ADDENDUM NUMBER ONE TO PLANS AND SPECIFICATIONS FOR 2012 STREET IMPROVEMENTS MANCHESTER, IOWA Project No. 112043.MS

2012 STREET IMPROVEMENTS
Project No. 112043.MS

INTERSECTION DETAILS
SHEET NO. N.01

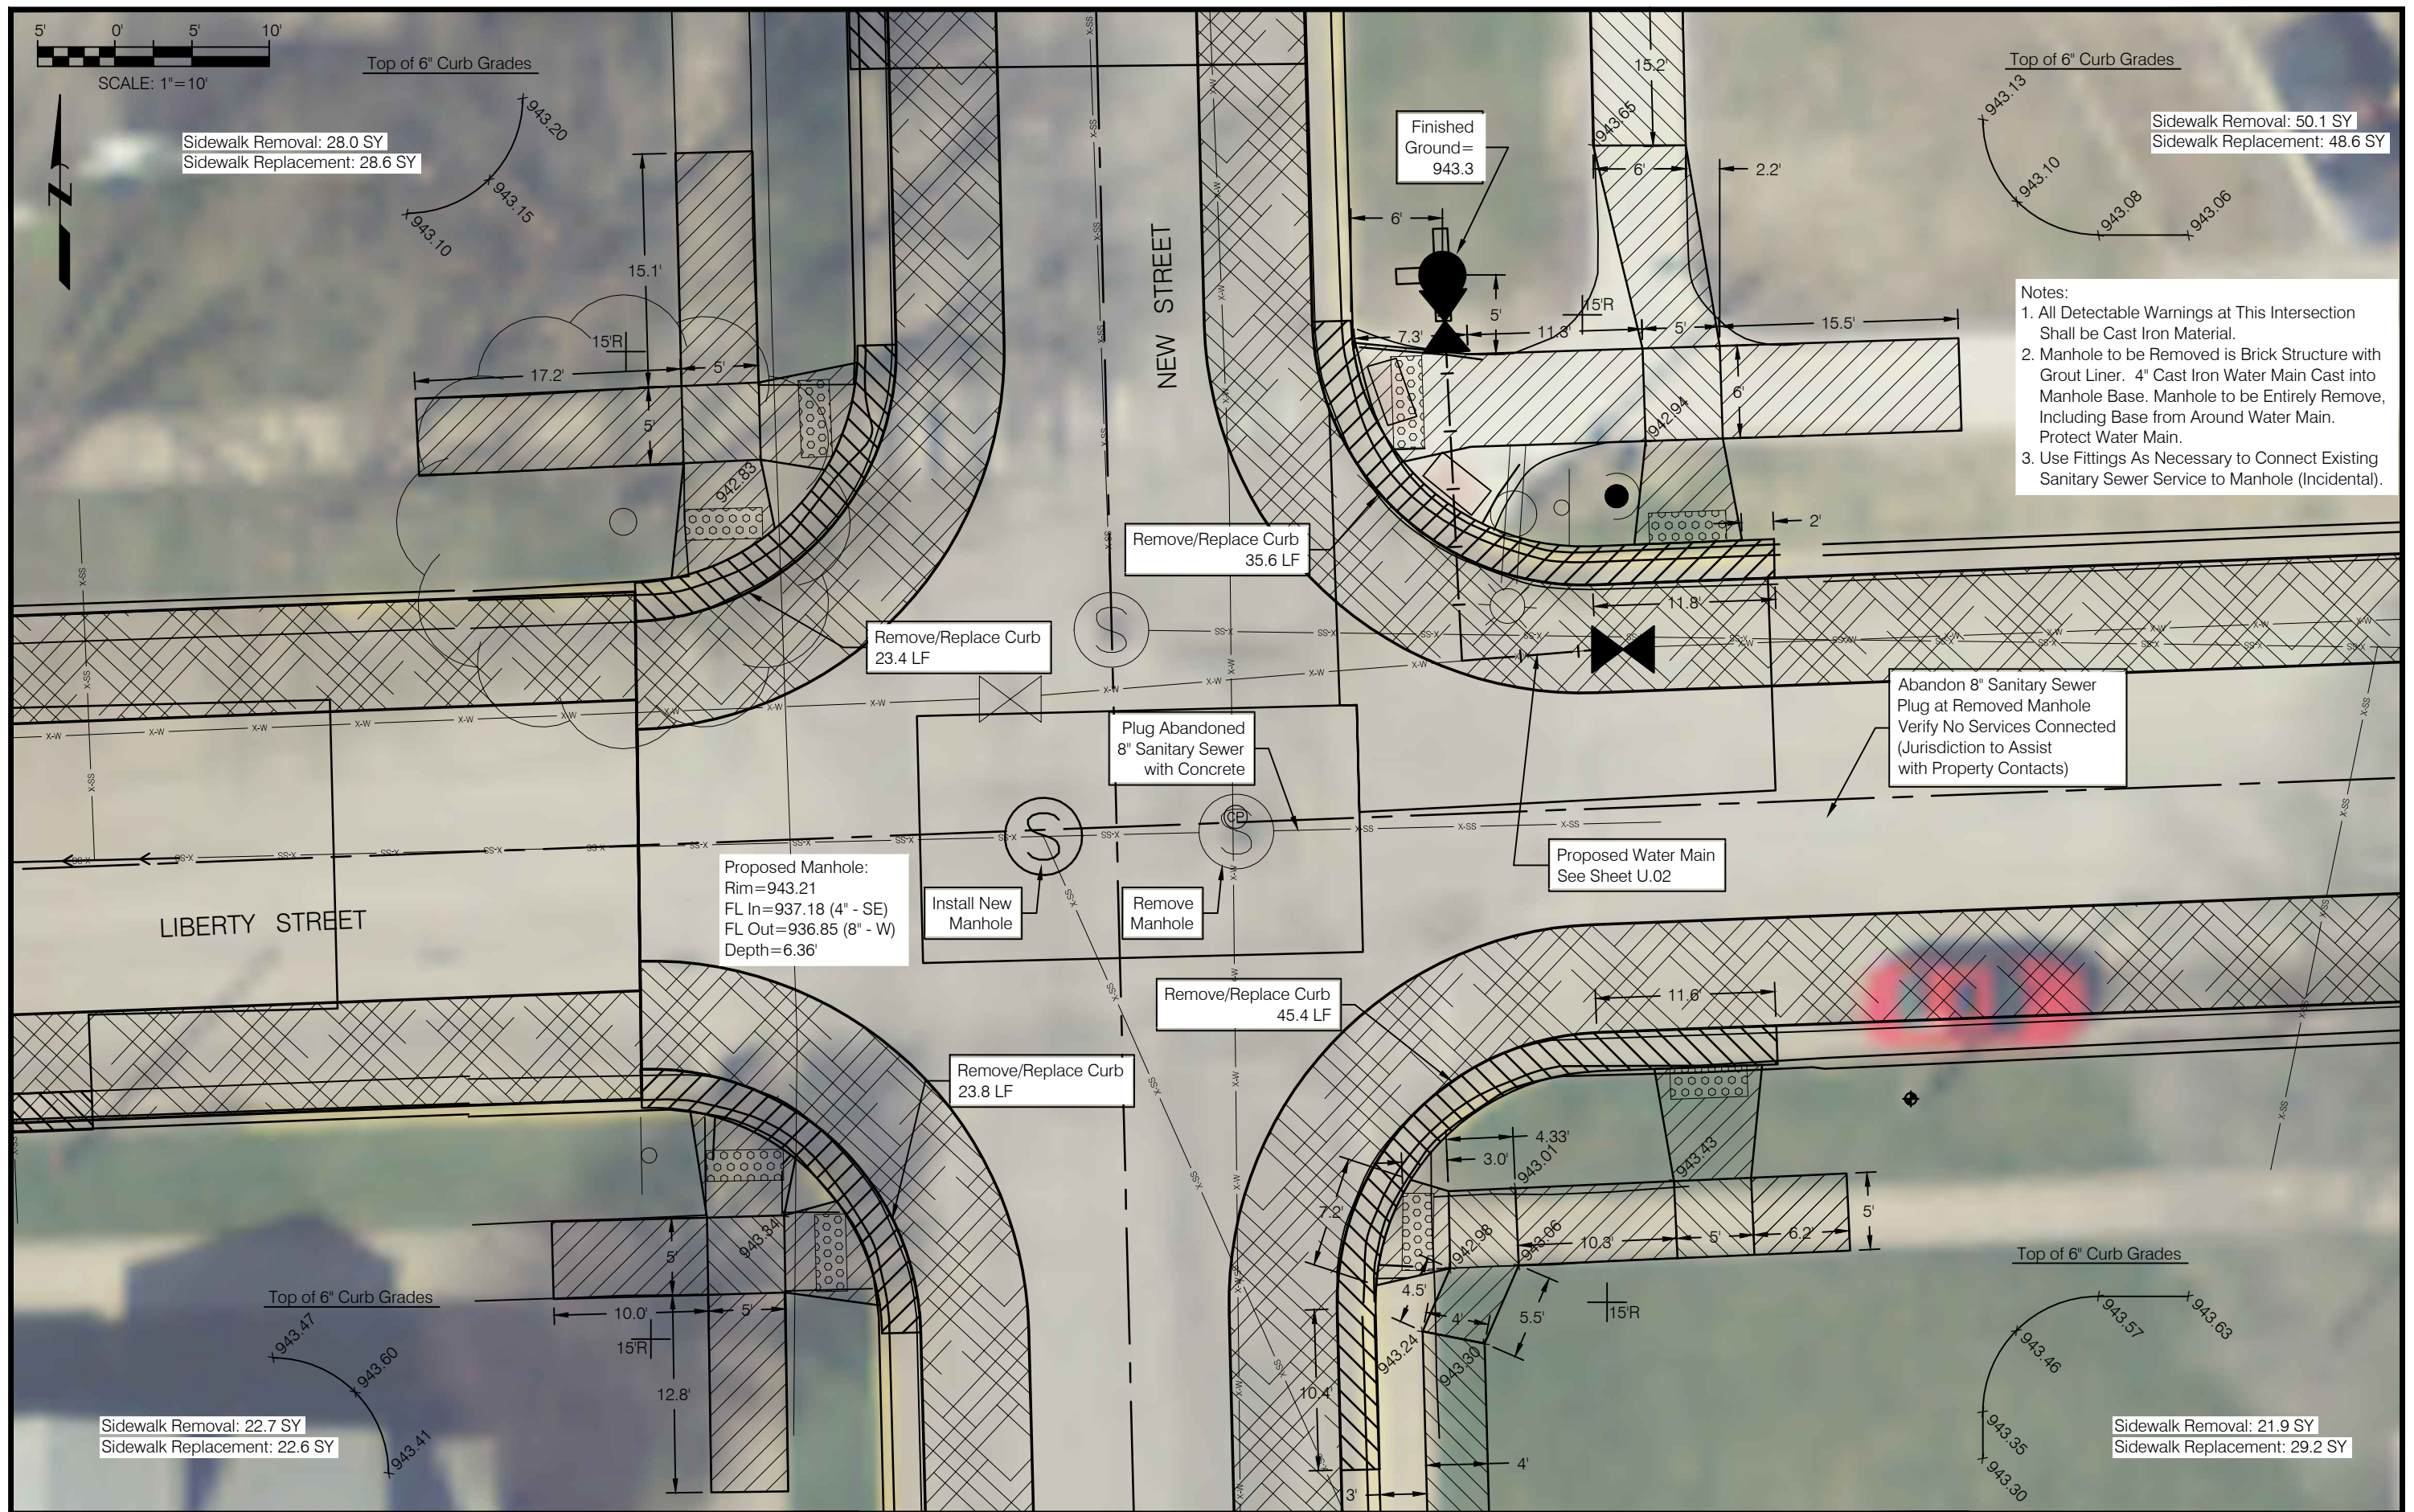
See revised Plan Sheets C.04, D.01, and N.01 attached. Sheet C.04 includes the additional sidewalk and water service work detailed below. Sheet D.01 includes additional sidewalk on the east side of New Street and change in location of said sidewalk in relation to the back of curb, with additional driveway installation related to the sidewalk additions. Sheet N.01 reflects the details at the sidewalk-sidewalk intersection at the southeast crosswalk at the intersection of New Street and Liberty Street.

- Notes:
1. All Detectable Warnings at This Intersection Shall be Cast Iron Material.
 2. Manhole to be Removed is Brick Structure with Grout Liner. 4" Cast Iron Water Main Cast into Manhole Base. Manhole to be Entirely Remove, Including Base from Around Water Main. Protect Water Main.
 3. Use Fittings As Necessary to Connect Existing Sanitary Sewer Service to Manhole (Incidental).

Proposed Manhole:
Rim=943.21
FL In=937.18 (4" - SE)
FL Out=936.85 (8" - W)
Depth=6.36'

Plug Abandoned
8" Sanitary Sewer
with Concrete

Abandon 8" Sanitary Sewer
Plug at Removed Manhole
Verify No Services Connected
(Jurisdiction to Assist
with Property Contacts)
